**RE: Suitability of additional ramp at 227 Bungaribee Rd, Blacktown NSW 2148**

## **1. Summary**

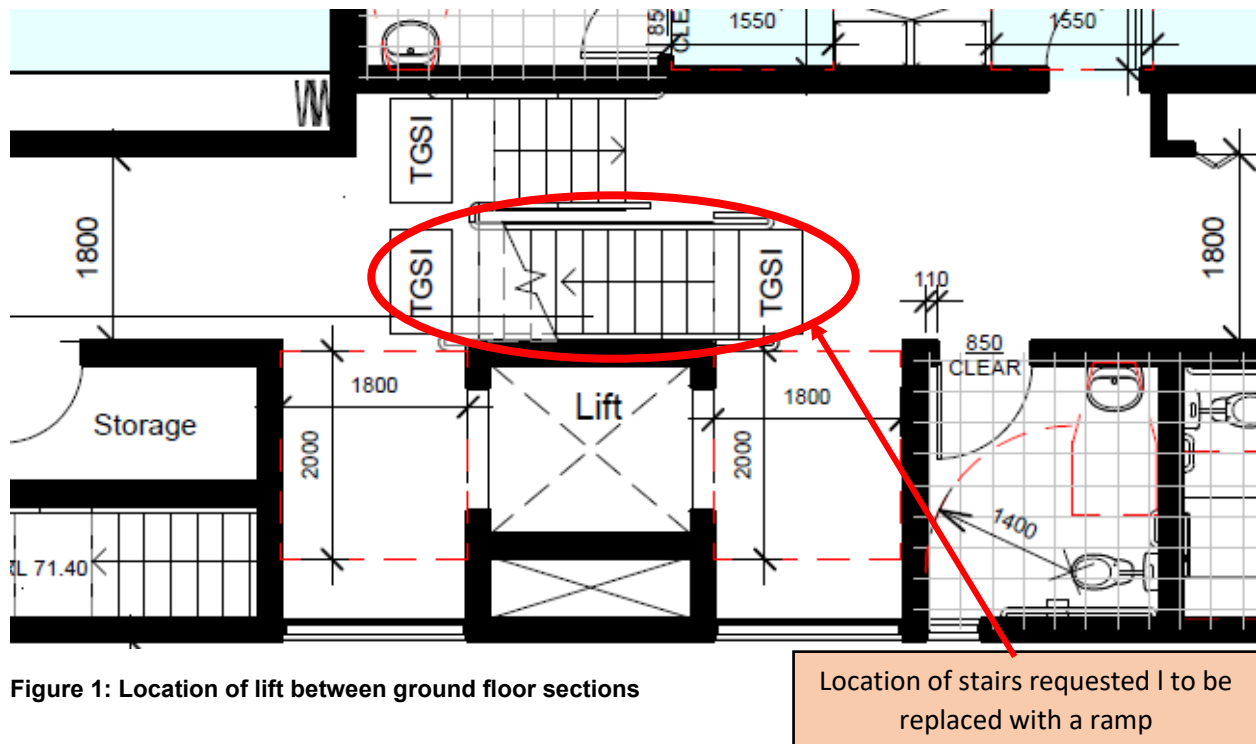
The building contains 11 sole occupancy units and has been provided with 2 accessible sole occupancy units at the ground level. As the proposed building is to be constructed over a slope, the ground floor is split into two sections, with the entrance being at RL 71.40 and the rear section being at RL 69.52. The layout is illustrated at figure 1 below:

Access to the sole occupancy units, as well as the common areas, is via a lift situated between the entrance and the rear section, as shown in figure 1 above. The lift contains two openings at either side and will be programmed to be able to stop at the floor level for each of these sections. The BCA definition for *accessway* in a building is referring to the term *continuous accessible path of travel* in Clause 6 AS 1428.1. That excludes listed impediments however does not exclude lifts. BCA clause D3.3 (b) further defines the requirements for lifts in accessible buildings:

As shown on plans, the lift is provided with openings on each level of the first floor i.e., the lift has been designed to service both levels of the first floor.

Figure 2: Length required for a 1:14 ramp

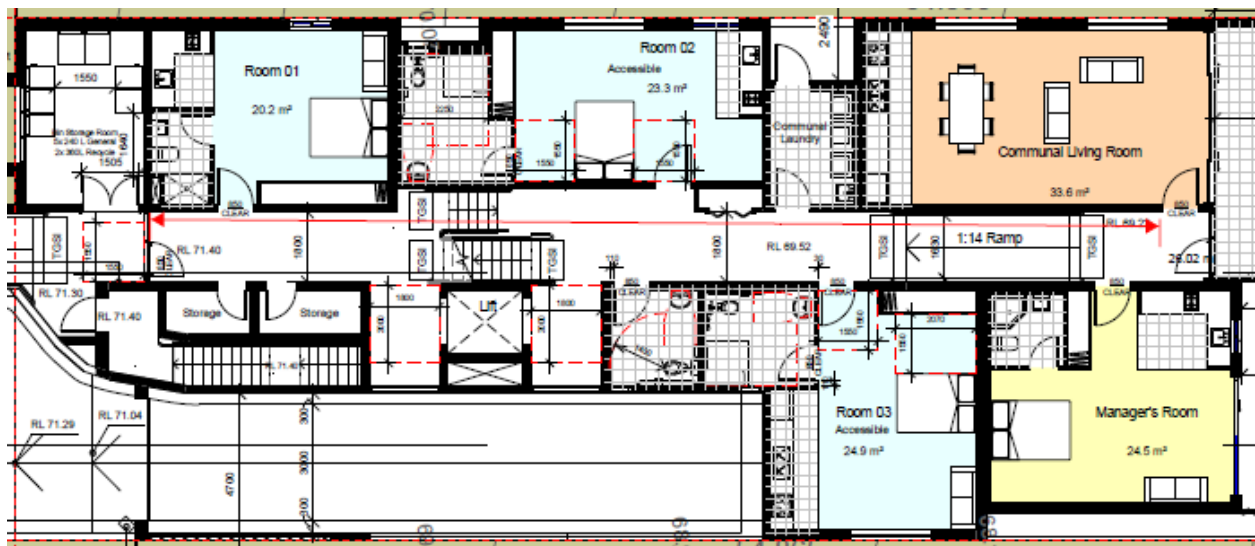
Similarly, there is not enough space in the current development to install a ramp of 1:14 which may traverse the 1.88 m between the sections of the ground floor. This would require the ramp to be over 30 m long including required landings. As the length of the building is only 31.5 m such a ramp would not only take up an unreasonable amount of space, it will be unreasonable to require occupants to travel back and forth over a 30 m long ramp to reach their unit when they could instead use a lift. Figure 2 below illustrates the length required for an AS1428.1 compliant ramp in relation to the building not considering the additional space for landing:

Given the 1.88 m difference in floor level between the two sections at the ground floor, the use of a passenger lift to travel between these floors levels is the only practical manner in which BCA compliant access can be provided for this building.

Figure 3: Location of hypothetical ramp

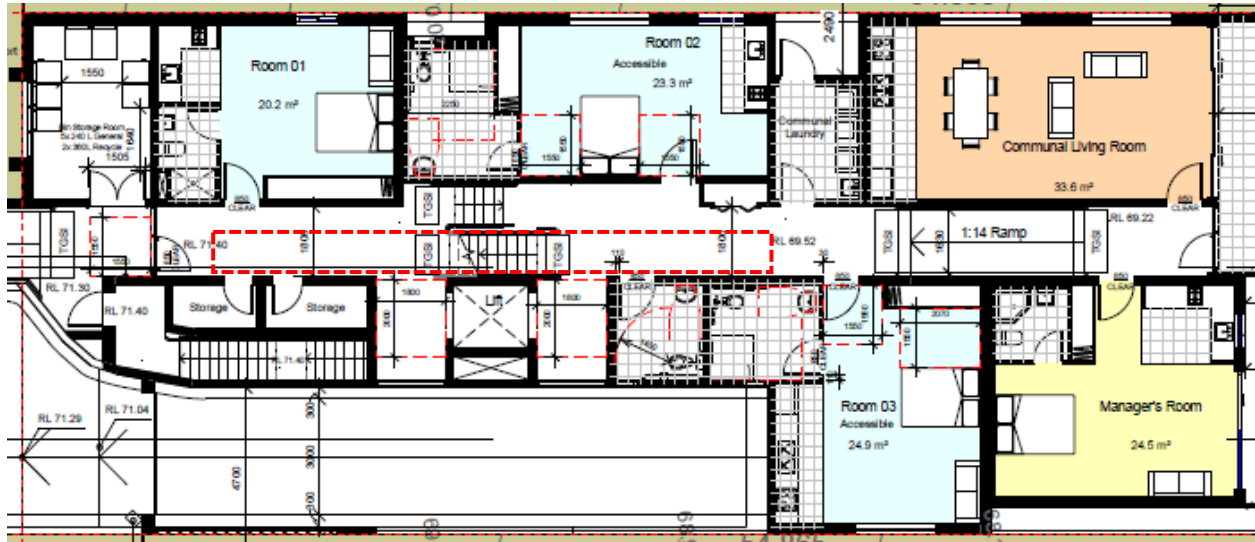
Even if a ramp was to hypothetically be installed in lieu of the stairs, as shown in figure 3 above, use of a ramp would result in non-complying circulation spaces at doorways and actual blockage of access into the communal living room, managers room, communal laundry, common area toilet and render access to the first floor via the lift impossible. This results in a non-compliance with clauses D3.1 as common areas are no longer accessible and D3.2 as the lift from the basement carpark can no longer be used to access the ground floor.

As the width of the corridor is only 1.8 m at parts, installing a ramp within this corridor will result in non-compliances with BCA clause D1.6 regarding the fire safety in relation to paths of travel to exits, as the passageway used for egress at Room 01 and Room 2 is less than 1 m.

Installing a ramp within the building corridor will also result in inadequate circulation space for the doorways outside Room 01 and Room 02 as required under AS1428.1, which is of particular significance for Room 02 as this is an accessible sole occupancy unit. Additionally, a ramp will also potentially result in inadequate circulation space at the entrance doorway as well as the laundry. Inadequate circulation space is a non-compliance under BCA clause D3.3.
